Project	IEEE 802.16 Broadband Wireless Access Working Group < http://ieee802.org/16 >	
Title	Credit token based coexistence protocol text update to consider inter-system communication MAC messages encapsulation changes	
Date Submitted	2007-09-07	
Source(s)	David Grandblaise Motorola Labs Parc Les Algorithmes Commune de Saint Aubin 91193 Gif sur Yvette, France	Voice: +33 (0)1 6935 2582 mailto: david.grandblaise@motorola.com
Re:	IEEE 80216h-07/019	
Abstract	Contribution IEEE C802.16h-07/077 has provided text remedy on inter-system communication MAC messages encapsulation. These changes on the messages require adapting consequently some additional text on the credit token based coexistence protocol (CT-CXP) within section 15.4.2.4 and 15.6.2.	
Purpose	Consolidation of draft D2c on credit token based coexistence protocol	
Notice	<i>This document does not represent the agreed views of the IEEE 802.16 Working Group or any of its subgroups. It represents only the views of the participants listed in the "Source(s)" field above. It is offered as a basis for discussion. It is not binding on the contributor(s), who reserve(s) the right to add, amend or withdraw material contained herein.</i>

Figure h67: Whole CT-CXP Procedure

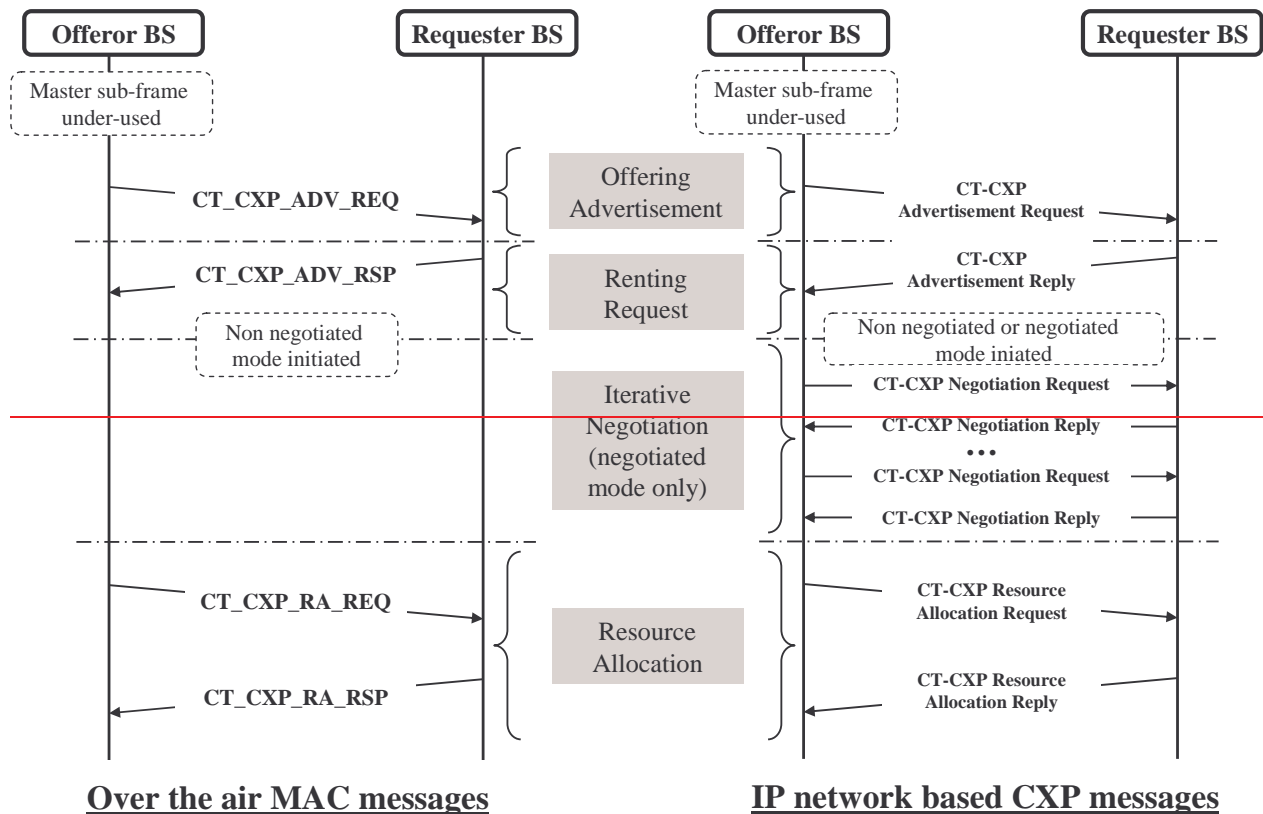
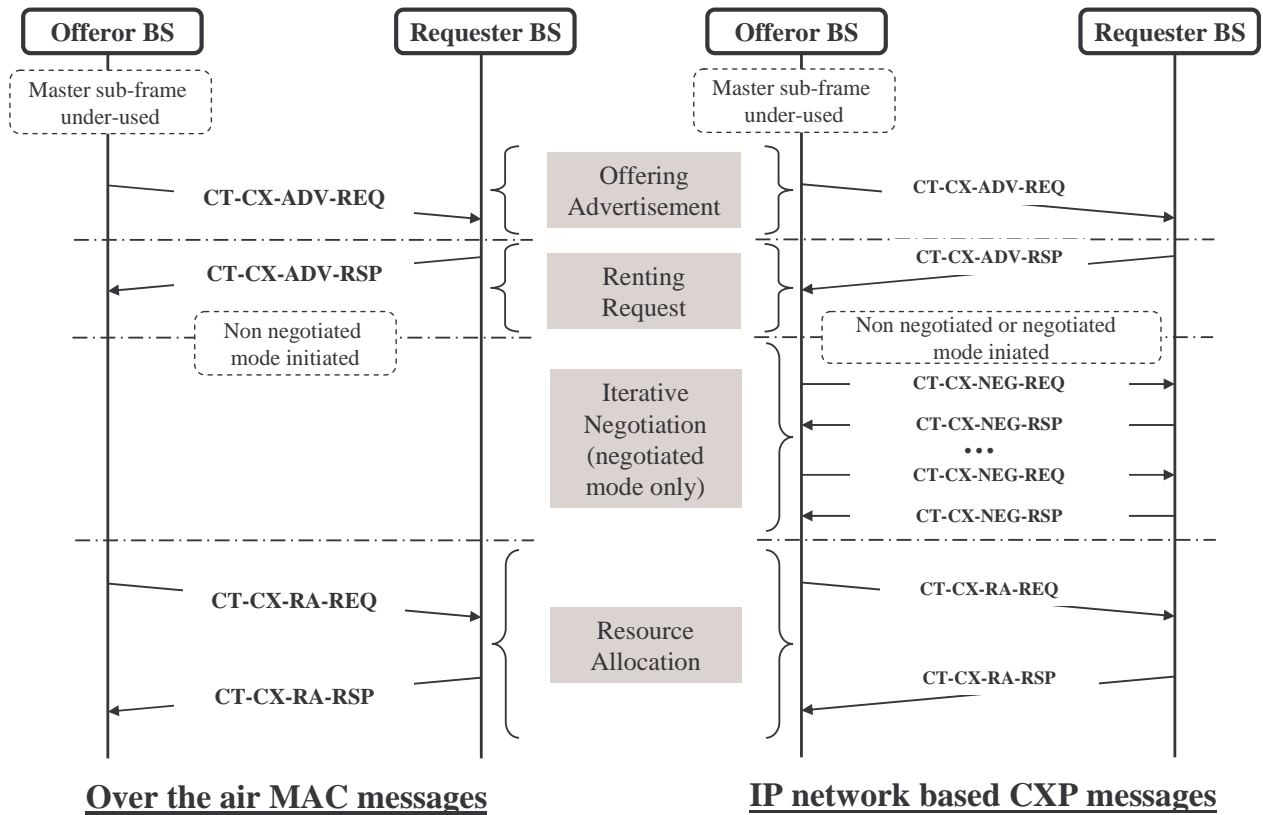
CT-CXP is composed of several consecutive procedures (offering advertisement, renting request, iterative negotiation, and resource allocation) as shown in *Figure h67*. For the sake of simplicity, this figure is only depicted for one (among multiple) requesters. Over the air based instantiation of CT-CXP for the non negotiated mode is depicted on the left hand side of *Figure h67*. The over IP network based instantiation of CT-

CXP for the negotiation or non negotiated mode is depicted on the right hand side of *Figure h67*. Inter system over the air messages are encapsulated MAC messages within CX-REQ-MAC and CX-RSP-MAC messages (section 6.3.2.3). ~~related to the over the air instantiation are specified in section 6.3.2.3.~~ Inter system over the air communications mechanisms are described in subclause 15.6. CXP messages related to IP network based instantiation are specified in section 15.5.1. The offering advertisement message (~~CT-CX-ADV-REQ~~ **CT-CXP Advertisement Request**) specifies which negotiation mode is used by the CT-CXP. The iterative negotiation procedure is executed only with the negotiated mode and not with the non-negotiated mode.

[Replace Figure h67 with the following updated one as indicate:]

Figure h68: Over the air based CT-CXP offering procedure

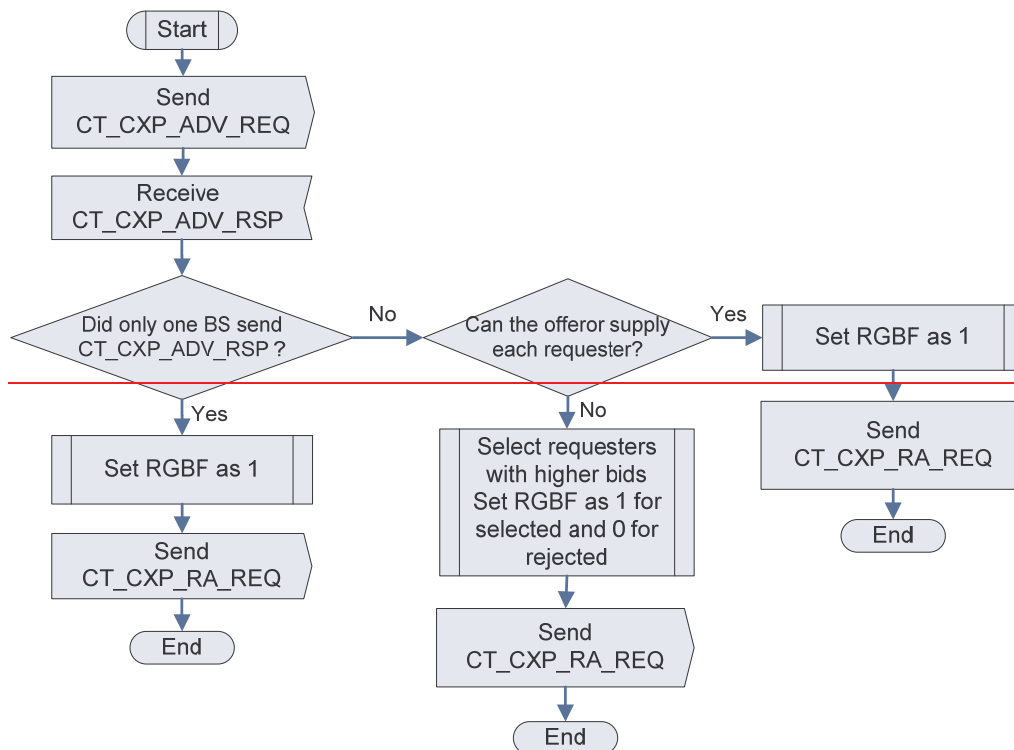
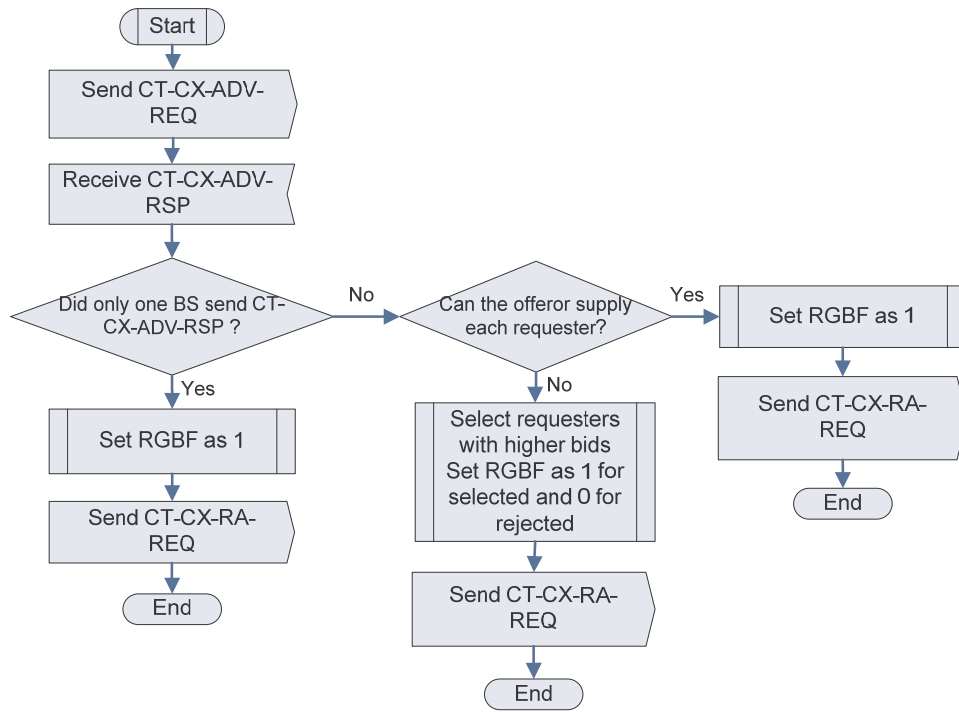
- A BS identifies that a part of its master subframe is going to be under-used and can be rented out. With respect to this, this BS becomes an offeror BS and initiates the renting advertisement by broadcasting the CT-CX-ADV-REQ~~CT-CXP_ADV_REQ~~ message. In particular, this message includes information related to the available resource (T_renting_subframe, Renting_out_start_time, Renting_out_end_time) as well as the renting conditions (MNCT: Minimum number of credit tokens per resource unit required per requester's bid), and also a list (LC: List of Channels) of other channels (frequency domain) proposed by the offeror BS for renting.

- If the offeror BS receives one single CT-CX-ADV-RSP~~CT-CXP_ADV_RSP~~ message, then the offeror BS grants the renting resource to the single requester by setting the Resource Granting Bit Flag (RGBF) to 1 in the CT-CX-RA-REQ~~CT-CXP_RA_REQ~~ message. The granted requester is not charged with credit token since it is not competing with some other requesters.

- If the offeror BS receives more than one CT-CX-ADV-RSP~~CT-CXP_ADV_RSP~~ message, then it assesses whether he can supply each requester or not:
 - If it can supply, the offeror BS grants the renting resource to all requesters by setting the Resource Granting Bit Flag (RGBF) to 1 in the CT-CX-RA-REQ~~CT-CXP_RA_REQ~~ message.

- If it cannot, the offeror BS derives and selects requesters with higher bids based on the information received from competing requesters. The offeror BS grants the resource to the selected requesters by setting the Resource Granting Bit Flag (RGBF) to 1 in the CT-CX-RA-REQ message. These selected requesters can access to their requested resource Rented_resource_amount from Renting_subframe_start_time to Renting_subframe_end_time during the guaranteed requested time period (Renting_in_start_time, and Renting_in_end_time). RGBT is set to 0 for the non selected requesters.

- The CT-CX-RA-REQ message includes the clearing price (Clearing_price). Derived from the selection process, the clearing price corresponds to the number of credit tokens per RRU that has to be frozen to acquire the granted resources. ~~considered in the pricing method specified within PBF of CT-CXP Advertisement Request message.~~

[Replace Figure h68 with the following updated one as indicate:]

Figure h69: IP network based CT-CXP offering procedure

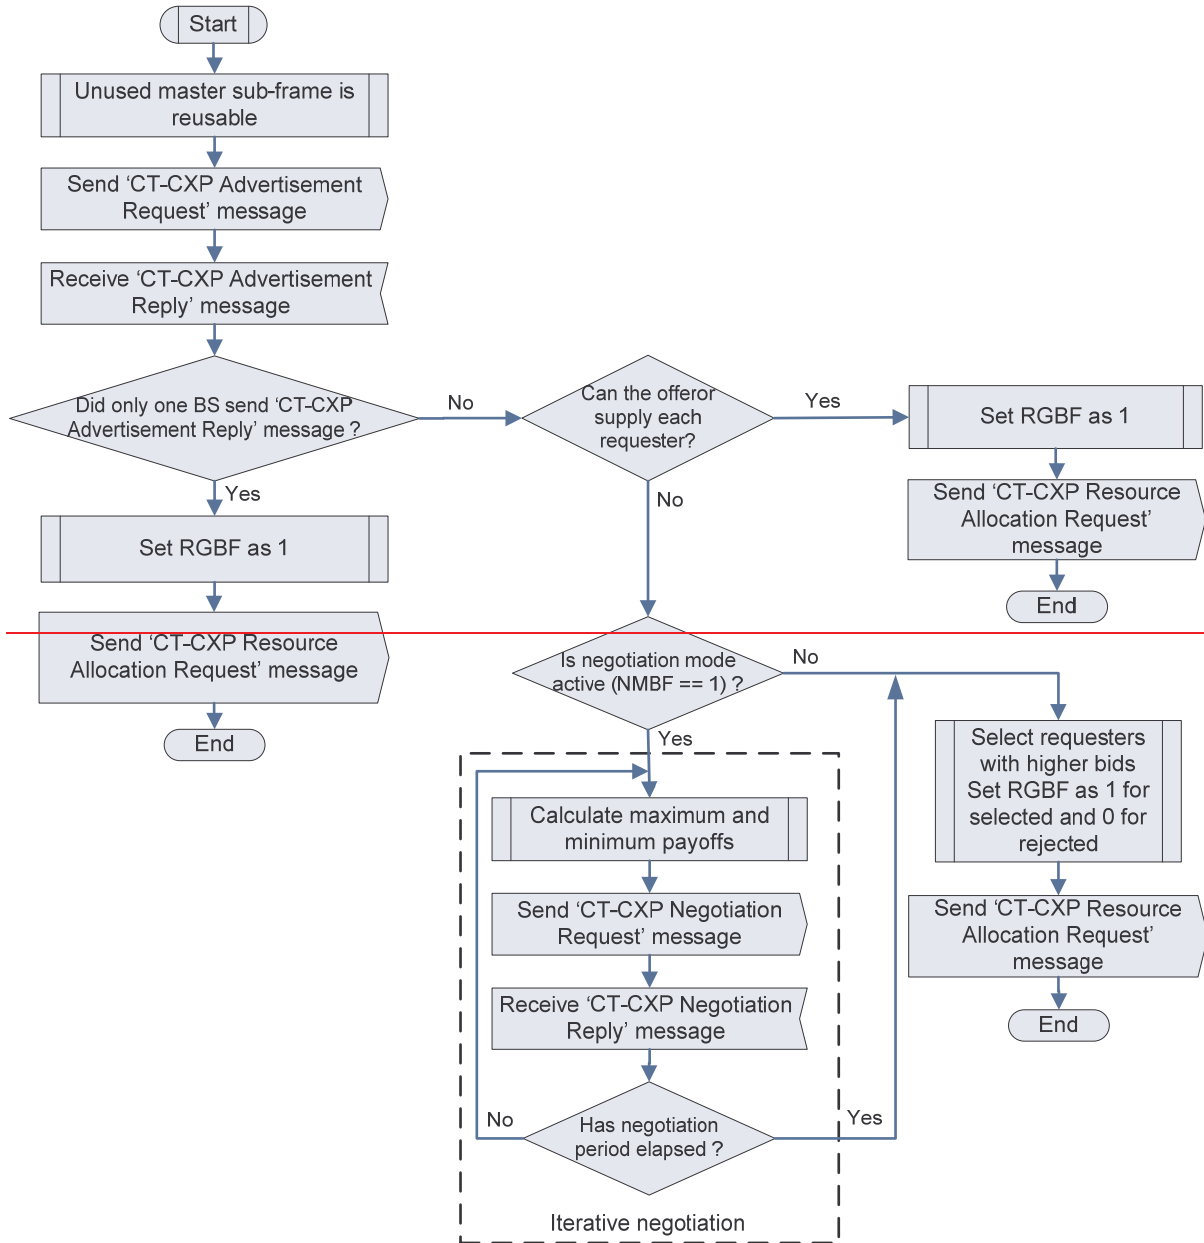
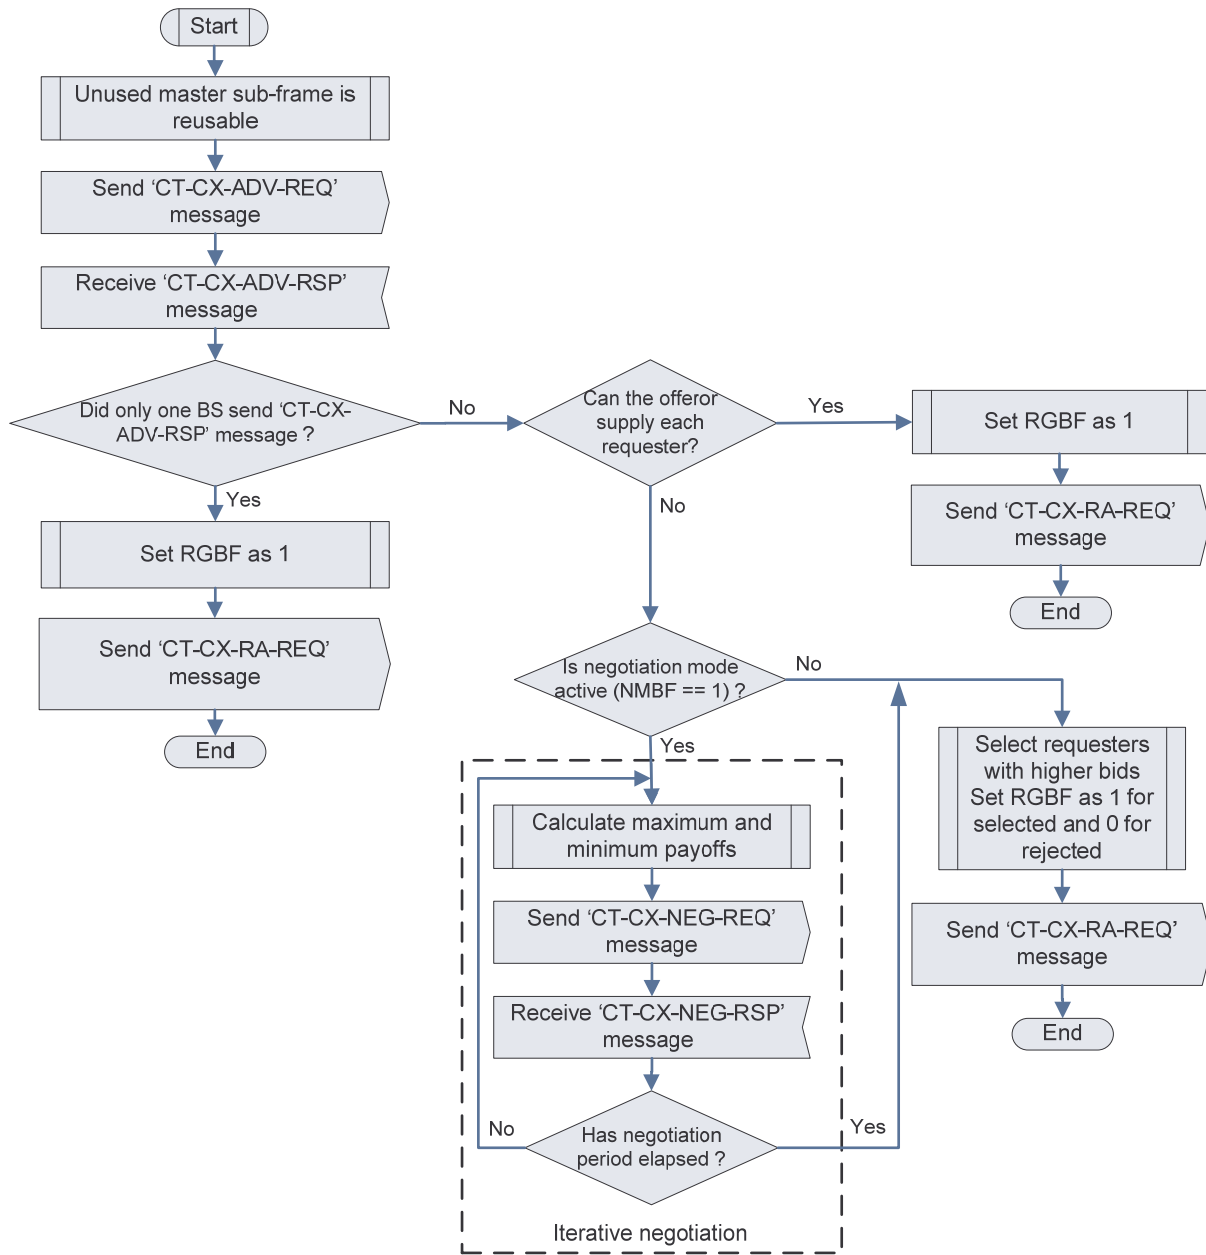
- A BS identifies that a part of its master subframe is going to be under-used and can be rented out. With respect to this, this BS becomes an offeror BS and initiates the renting advertisement by broadcasting the CT-CX-ADV-REQ “~~CT-CXP Advertisement Request~~” message. In particular, this message includes information related to:

- The renting conditions (Start_negotiation_time, End_negotiation_time, MNCT, LC),
 - The pricing method in case NMBF == 1.
- If the offeror BS receives one single CT-CX-ADV-RSP “~~CT-CXP Advertisement Request~~” message, then the offeror BS grants the renting resource to the single requester by setting the Resource Granting Bit Flag (RGBF) to 1 in the CT-CX-RA-REQ “~~CT-CXP Resource Allocation Request~~” message. The granted requester is not charged with credit token since it is not competing with some other requesters.

- If the offeror BS receives more than one CT-CX-ADV-REQ “~~CT-CXP Advertisement Request~~” message, then it assesses whether he can supply each requester or not:

- If it can supply, the offeror BS grants the renting resource to all requesters by setting the Resource Granting Bit Flag (RGBF) to 1 in the CT-CX-RA-REQ “~~CT-CXP Resource Allocation Request~~” message.

- If it cannot, the offeror BS follows the negotiated mode under consideration:
 - If NMBF == 0, same procedure as a) is executed. The offeror BS derives and selects requesters with higher bids based on the information received from competing requesters. The offeror BS grants the resource to the selected requesters by setting the Resource Granting Bit Flag (RGBF) to 1 in the CT-CX-RA-REQ “~~CT-CXP Resource Allocation Request~~” message. These selected requesters can access to their requested resource

- If NMBF == 1, iterative negotiation occurs between the offeror BS and each requester BS. Based on the information received within the ~~CT-CX-ADV-RSP~~“~~CT-CXP Advertisement Reply~~” message, the offeror BS calculates respectively a minimum and maximum payoff (Minimal_payoff and Maximal_payoff) at each iteration. These payoffs allow selecting the remaining requesters at each iteration. An example of payoff calculation is given in section 15.4.2.4.2. At each iteration, Minimal_payoff and Maximal_payoff are sent within the ~~CT-CX-NEG-REQ~~“~~CT-CXP Negotiation Request~~” message. The iterative negotiation occurs until the negotiation period (bounded by End_negotiation_time) is elapsed. At the end of the negotiation, the final requesters are selected by the offeror BS. The offeror BS grants the resource to the selected requesters by setting the Resource Granting Bit Flag (RGBF) to 1 in the ~~CT-CX-RA-REQ~~“~~CT-CXP Resource Allocation Request~~” message. These selected requesters can access to their requested resource Rented_resource_amount from Renting_subframe_start_time to Renting_subframe_end_time during the guaranteed requested bounded time period (Renting_in_start_time, and Renting_in_end_time). RGBT is set to 0 for the non selected requesters.

[Replace Figure h69 with the following updated one as indicate:]

Figure h70: Over the air based CT-CXP requesting procedure

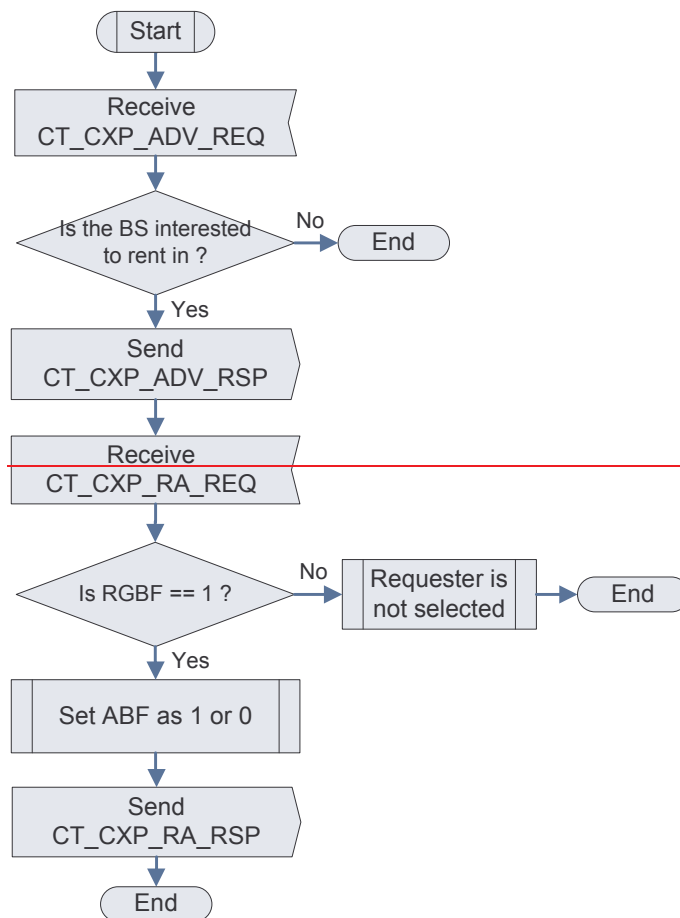
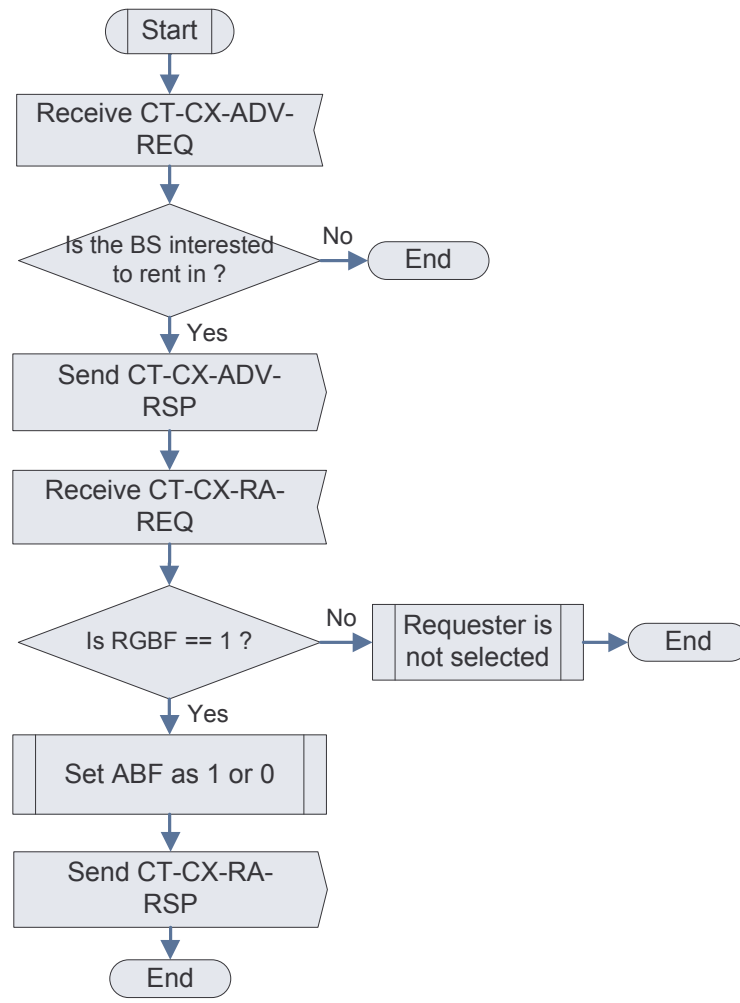
- If a BS is in need of additional resource and can meet MNCT requirements, he can make a request (CT-CX-ADV-RSPCT_CXP_ADV_RSP message) upon the reception of CT-CX-ADV-REQCT_CXP_ADV_REQ.

- Within ~~CT-CX-ADV-RSP~~~~CT_CXP_ADV_RSP~~, the requester informs about the amount of required resource (Rented_resource_amount), the rented in start and end time (Renting_in_start_time, Renting_in_end_time) and the requester's bid (Requester_bid) in term of number of credit tokens bidded per RRU.

- Upon reception of ~~CT-CX-RA-REQ~~~~CT_CXP_RA_REQ~~ message, the requester BS knows whether it has been selected or not. If RGBF is set to 1, the requester BS is selected, otherwise (RGBF set to 0) the requester is rejected.

- The requester decides to accept (Acceptation Bit Flag ABF set to 1) or to reject (ABF set to 0) the resource granting based on the Clearing_price information. This information is sent within the ~~CT-CX-RA-RSP~~~~CT_CXP_RA_RSP~~ message.

[Replace Figure h70 with the following updated one as indicate:]
